Application for Approval of Details Reserved by Condition Pursuant to Planning Permission Reference: 192928. Construction of the South Wokingham Distributor Road ('SWDR') at Land South of Wokingham, East of Finchampstead Road and West of Waterloo Road, Wokingham

**PLANNING PERMISSION 192928 (CONSTRUCTION OF THE SOUTH WOKINGHAM DISTRIBUTOR ROAD (SWDR)
BETWEEN FINCHAMPSTEAD ROAD AND WATERLOO ROAD, INCLUDING A LINK TO HEATHLANDS ROAD,
TOGETHER WITH ASSOCIATED WORKS)**

Further to my email of 13 May, below are the issues that need to be addressed before conditions details can be approved.

Condition 5 levels (213441)

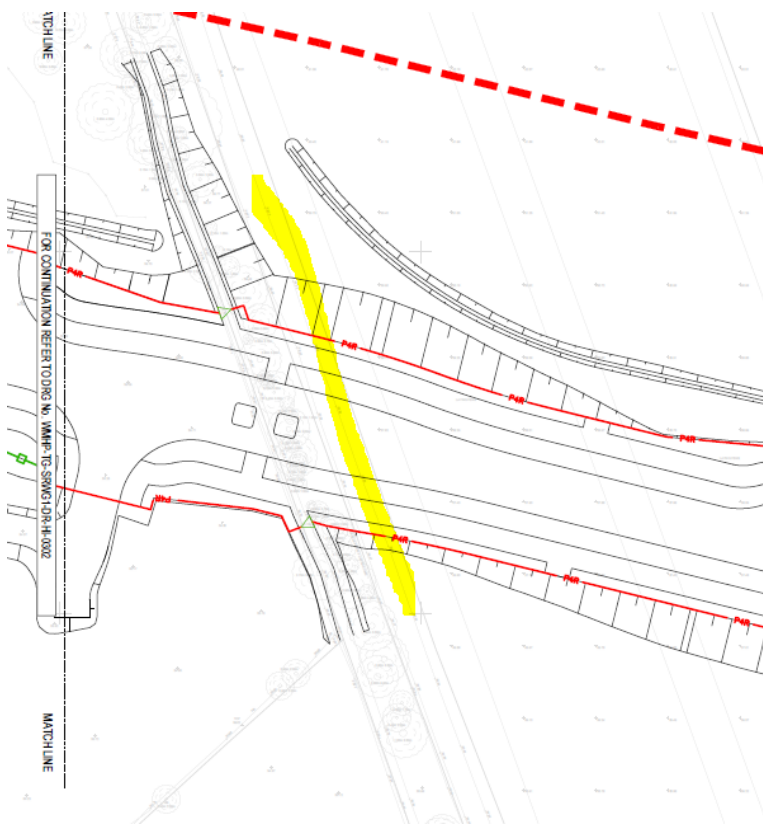
Please provide chainage drawings and longitudinal sections, as provided at the original application stage, showing existing, approved and proposed levels to allow comparison. I am aware that the consortium have raised concerns about the level of the road being increased and need to understand the scope of the issue.

and on WMHP-TG-SRWG1-DR-HI-301:

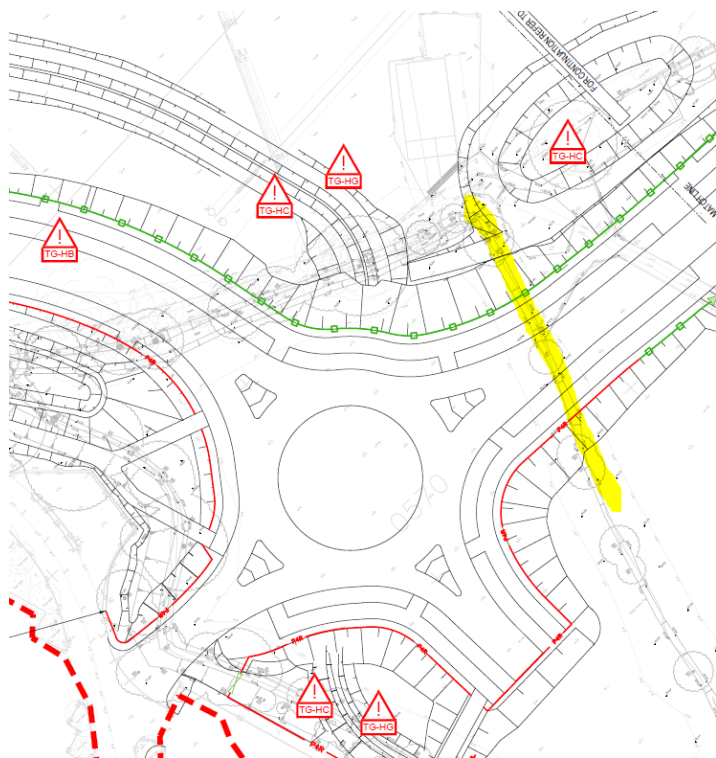
Additional mammal tunnels are required in these two locations, with reference to the fencing plans, on WMHP-TG-SRWG1-DR-HI-0303 (highlighted yellow):

Condition 11 AMS (213554)

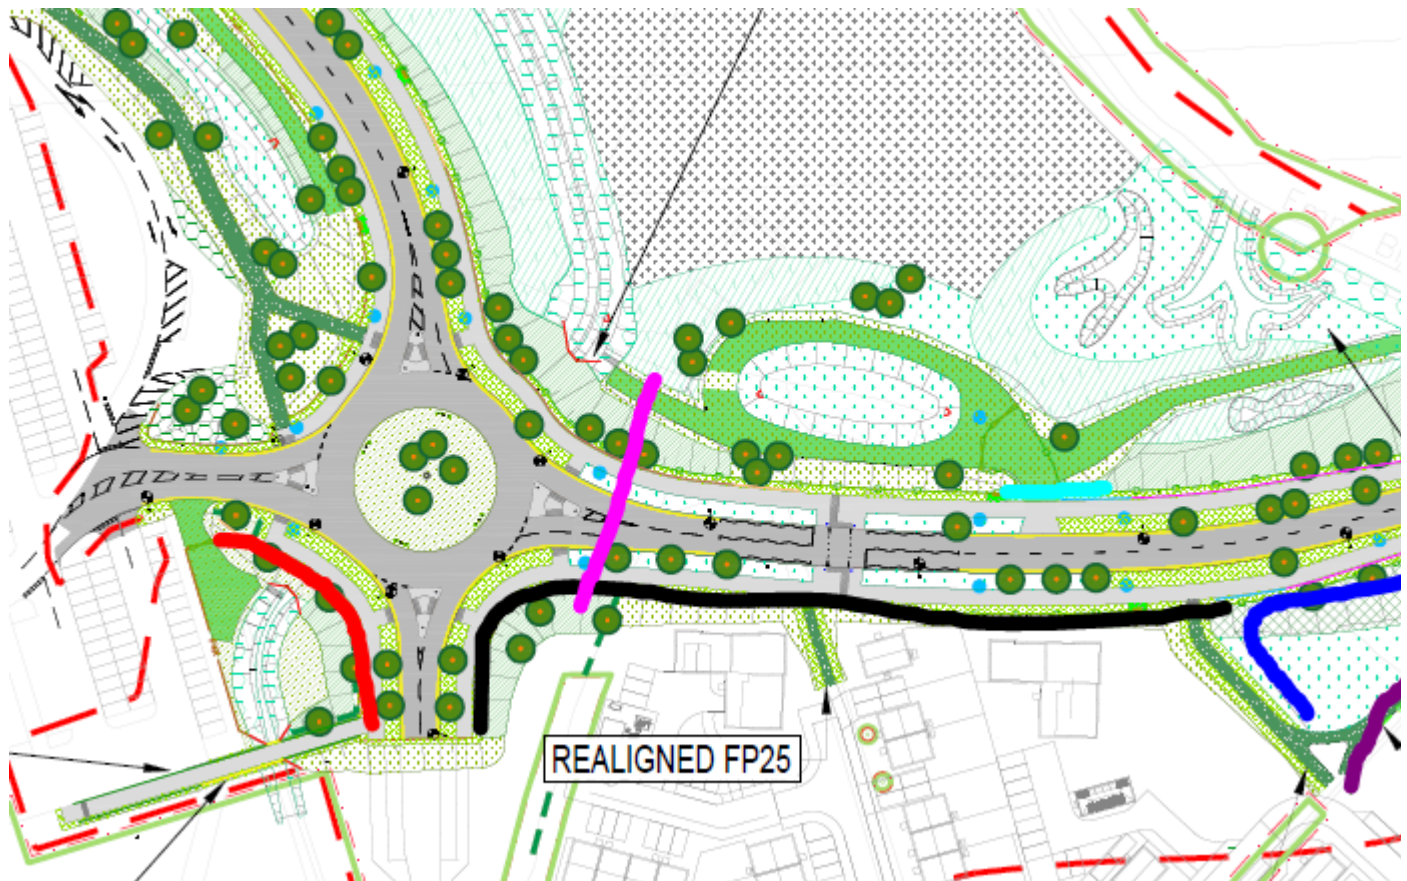
A revised AIA has been submitted but not an AMS which will need to be submitted to comply with this condition.
